Ashton-Ravensworth Underground Mine Integration Modification

Ravensworth Underground Mine

SUBMISSIONS REPORT

Figure 1

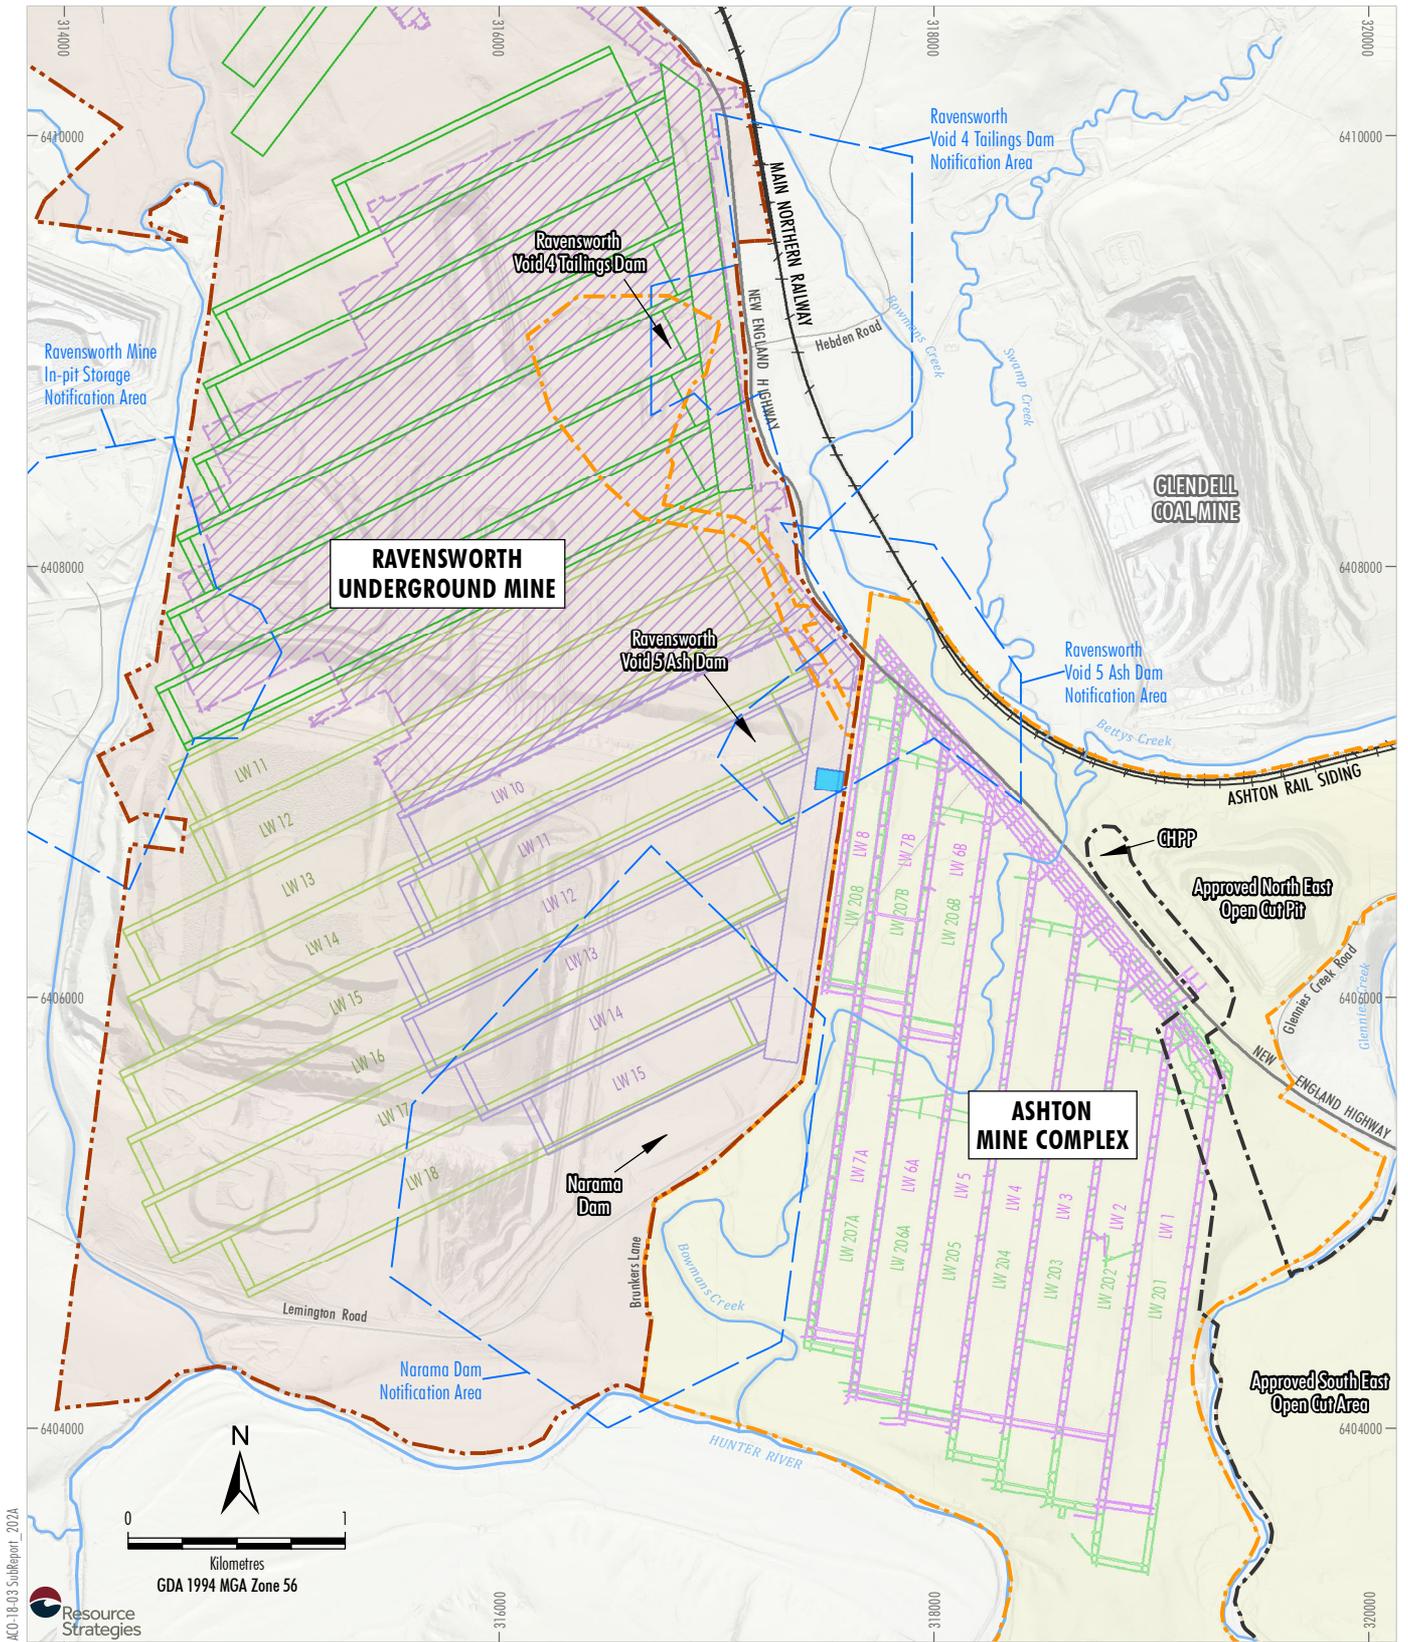
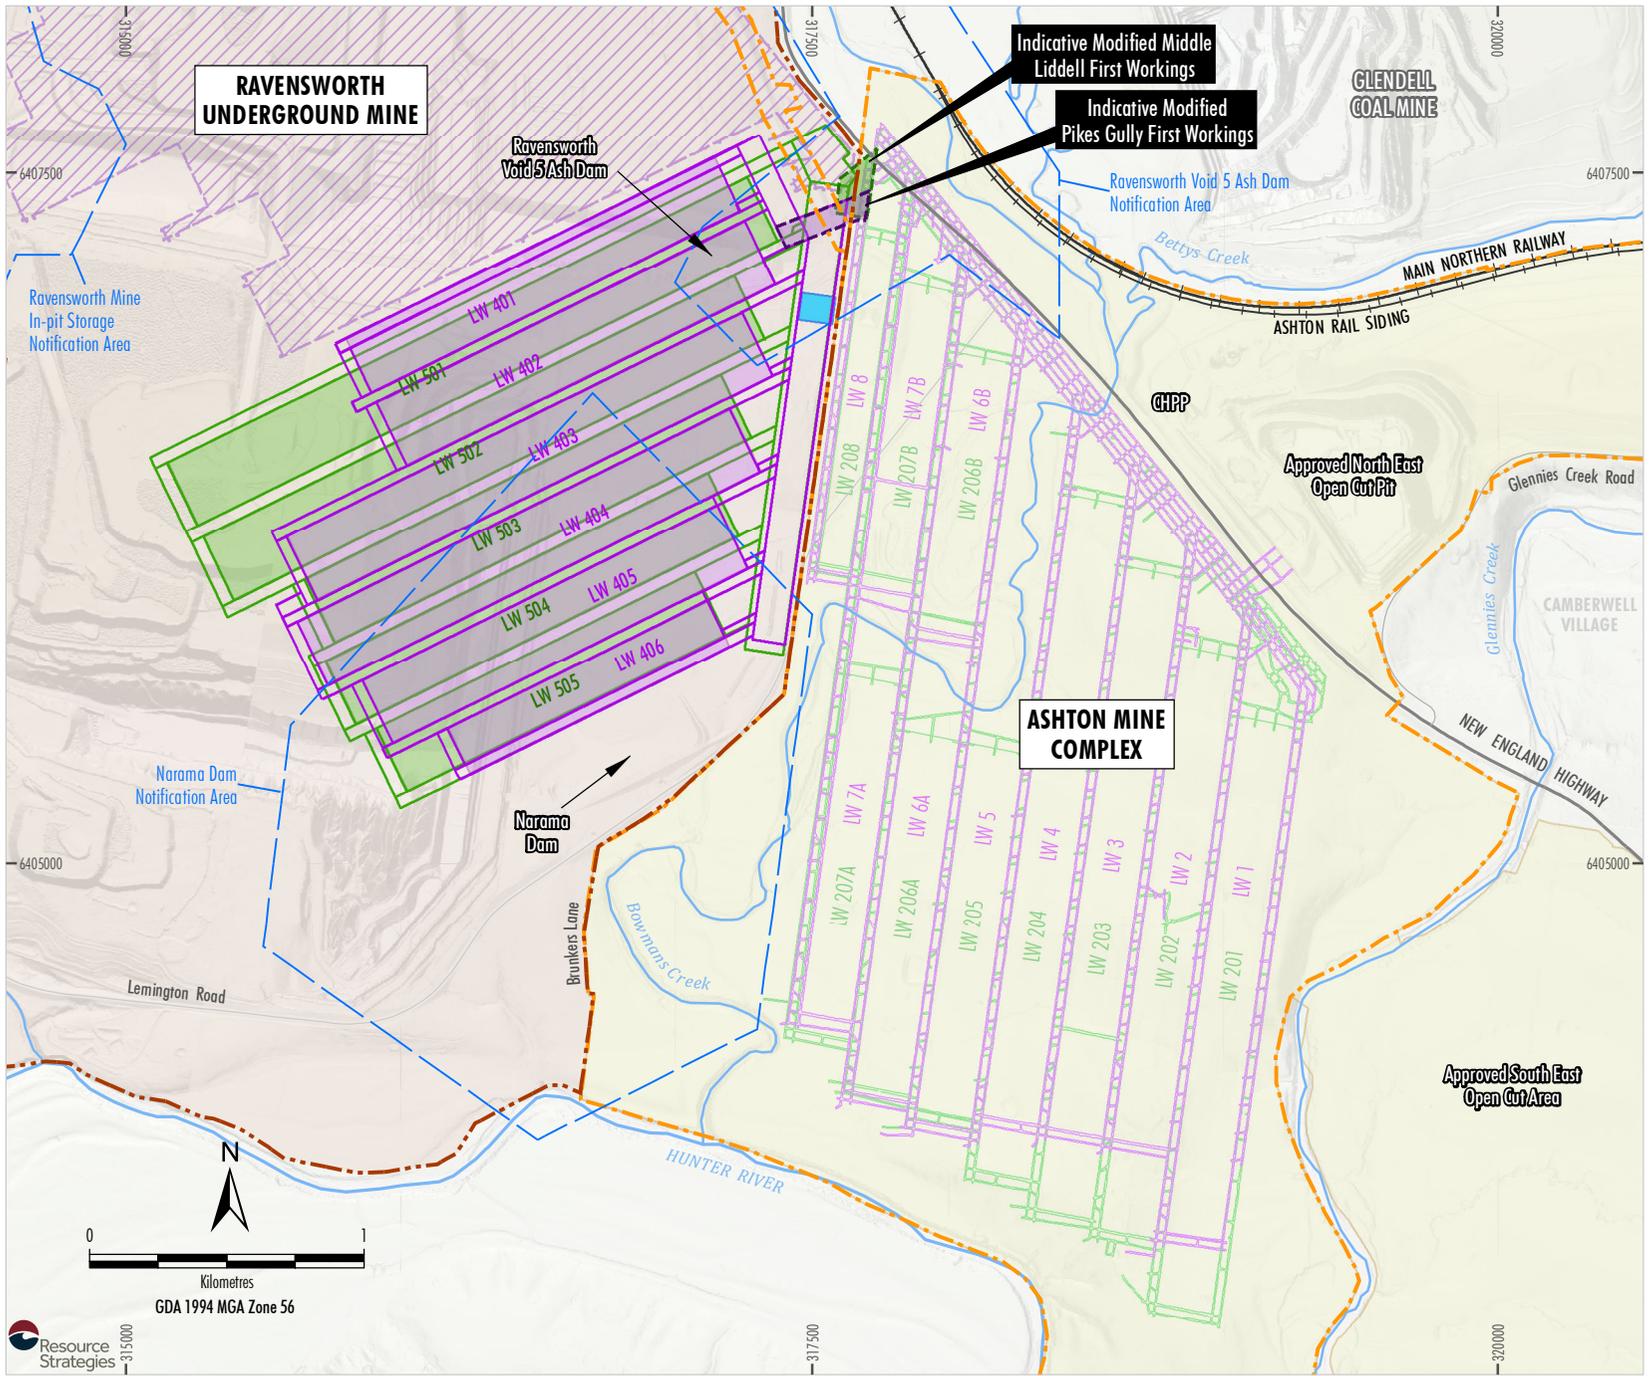
DPIE – Water noted that the contemporary groundwater model submitted was a summarised version of the inputs and outputs and does not satisfy the requirements of the Aquifer Interference Policy (AIP). The AIP states that for any mining or coal seam gas production activity not subject to the Gateway process, the impacts of the activity and predicted take of water are to be based on a complex modelling platform that is calibrated and validated, consistent with the Australian Groundwater Modelling Guidelines and independently reviewed.

DPIE – Water requested that Yancoal provide an independently reviewed contemporary groundwater model to confirm if there will be additional water take or groundwater interference from the proposed Modifications.

The commissioning of a peer review for the Modification Groundwater Review is considered to be over and above the contemporary practices for a modification application where impacts are substantially the same or, in this case, lower than the approved project. There would be no change in groundwater impacts at the Ashton Coal Project as there is no change to the Ashton longwall layout. Further, the corresponding RUM Modification application seeks to shorten the length of some of the approved longwall panels in the Middle Liddell Seam, thus the Modification would have a reduced mining footprint compared to the approved RUM (refer to Figures 1 and 2). In addition, the Modification only seeks to mine two of the four approved (i.e. Lemington, Pikes Gully, Liddell and Barrett) coal seams (Figures 1 and 2)².

² Figure 1 does not show the approved mining areas for the RUM Lemington and Barrett Seams as the Modification does not propose to mine these seams.

Chart 1
Predicted Post-mining Indirect Take from Surface Water and Alluvial Sources

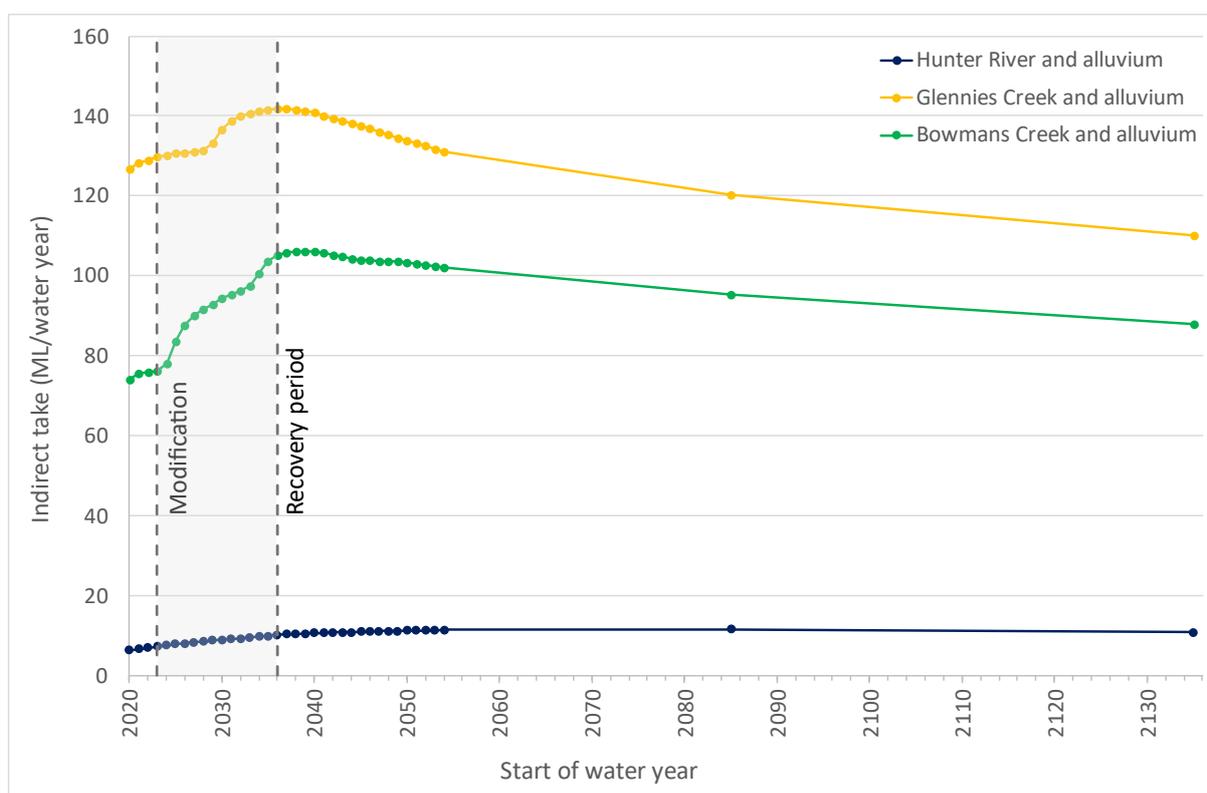
DPIE – Water noted that ACOL has not outlined a strategy to account for any water taken beyond the life of operation of the projects. Relevant water access licence entitlements would need to be retired at the completion of the Projects to account for groundwater take during the recovery of the groundwater system, post-mining. DPIE – Water requested that Yancoal provide the details on the predicted peak take post-mining and reconcile this take against the water access licences (WALs) held.

Predicted post-mining water take has been modelled by AGE using the same groundwater model peer reviewed by Dr Noel Merrick for the Modification, and is provided in Attachment 1. Chart 1 summarises the predicted post-mining groundwater take. A tabulation of the predicted indirect take from the surface water and alluvial sources for the modelled post-mining years is presented in Attachment 1.

During the post-mining period, inflows from the North Coast Fractured and Porous Groundwater Source into the completed workings would be less than the predicted peak take of 649.5 megalitres per year during mining (Attachment 1). While there is a minor increase in take during the early post-mining period for the surface water and alluvial sources (Attachment 1), ACOL holds relevant WALs with sufficient entitlements (as summarised in Table 4.1 of the Groundwater Review) to account for the predicted post-mining water take. Where required, ACOL would retire relevant licence entitlements in consultation with DPIE – Water following the completion of mining at the Ashton Coal Project.

Figure 3.1 Total predicted indirect take for each water source over the life of modification

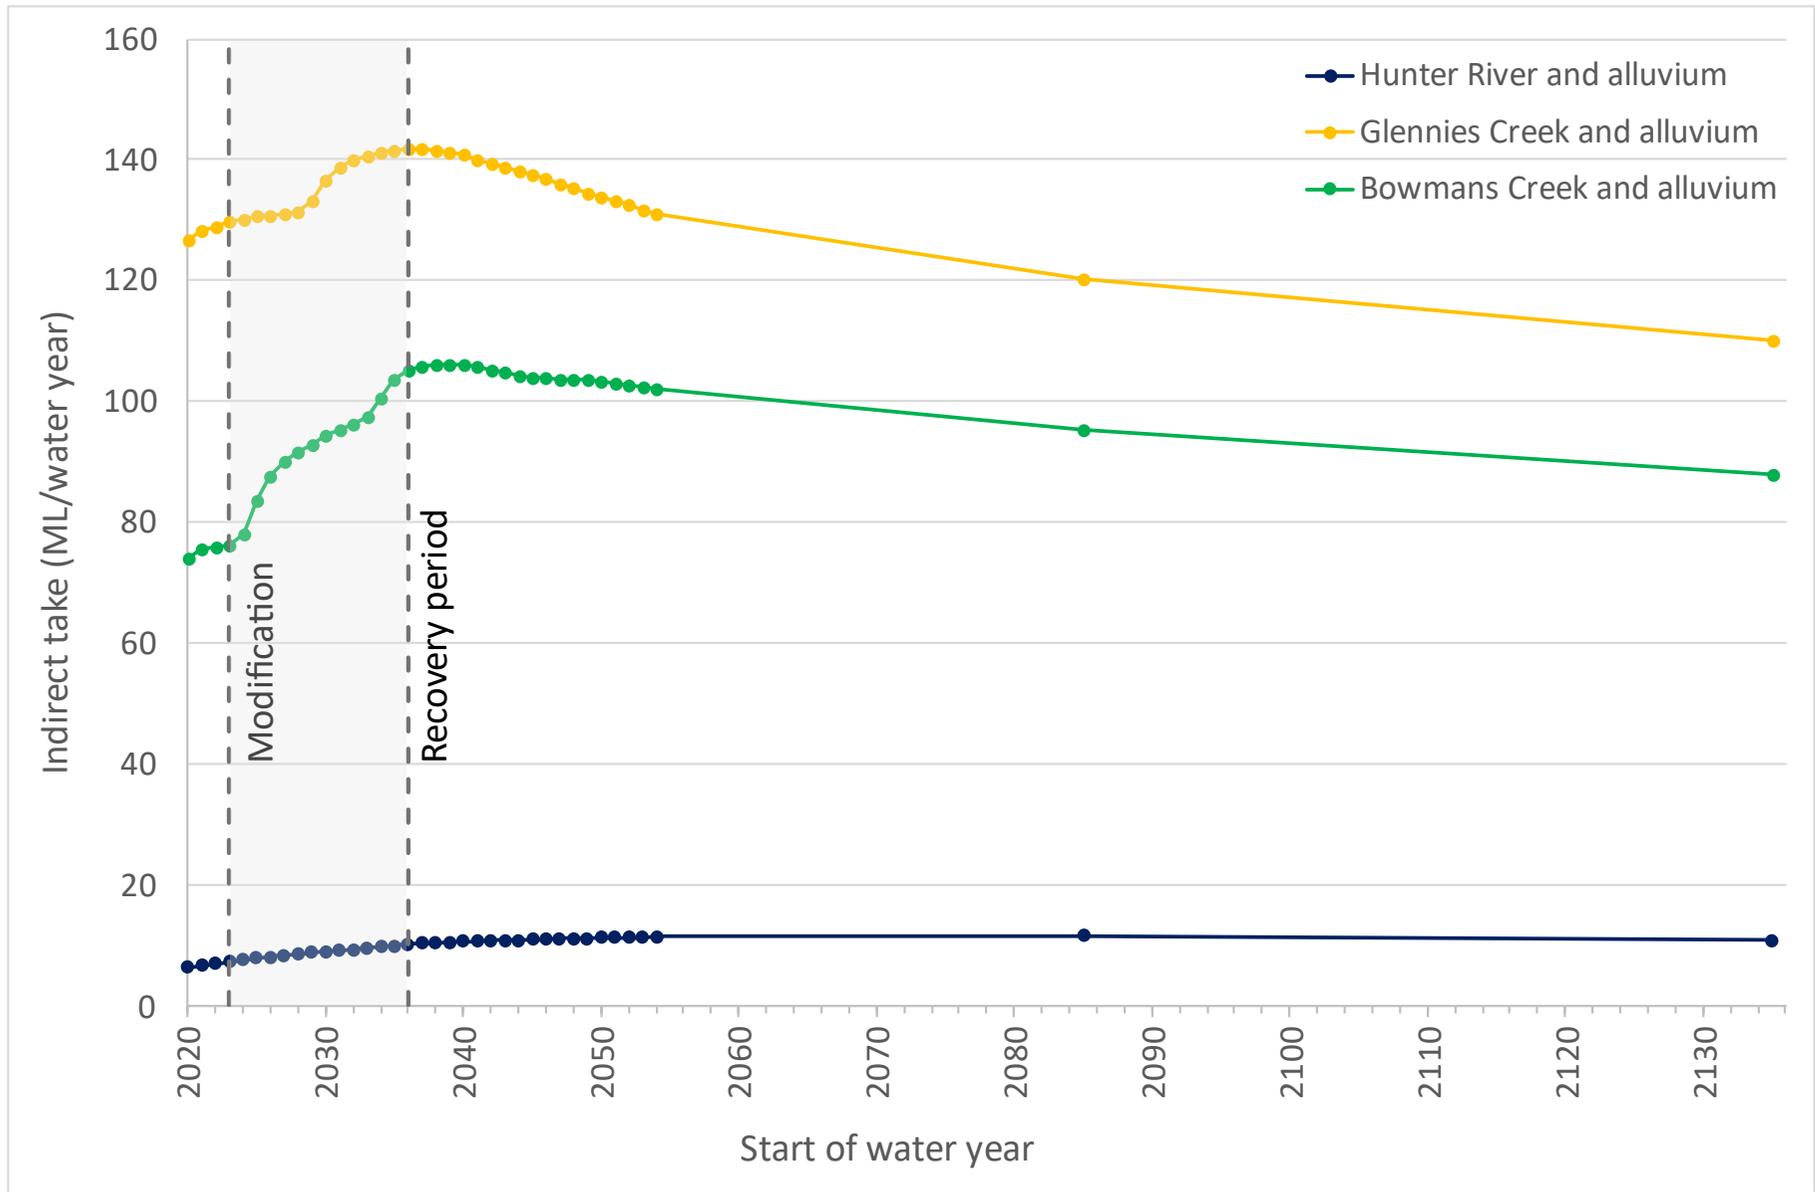
‘The proponent has not outlined their strategy to account for any water taken beyond the life of the operation of the projects. Relevant water access licence entitlement would need to be retired at the completion of the Projects to account for groundwater take during the recovery of the groundwater system, post-mining. The peak take for the alluvial systems is presented in Figure 4.8 of the Groundwater Review and shows an increasing trend up to 5 years post-mining modelled period. The predicted peak take post-mining should be reported and reconciled against WALs held.’

‘...provide the details on the predicted peak take post-mining and reconcile this take against the WALs held.’

The indirect take per river system, reported to peak by the end of simulation (December 2036) in AGE (2021), increased slightly early in the recovery period, before decreasing with time (Figure 3.1). The peak indirect take per water year occurred during the 2038-2039 water year for Glennies Creek and during 2039-2040 for Bowmans Creek (Figure 3.1; Table 3.2). The indirect take from the Hunter River system was stable, increasing annually by less than 0.1 megalitres per year (ML/year) from 2037-2038 through to the peak at 2085-2086, before declining thereafter.

ACOL holds WALs with sufficient entitlements to account for the peak predicted indirect take during the active mining and recovery periods.
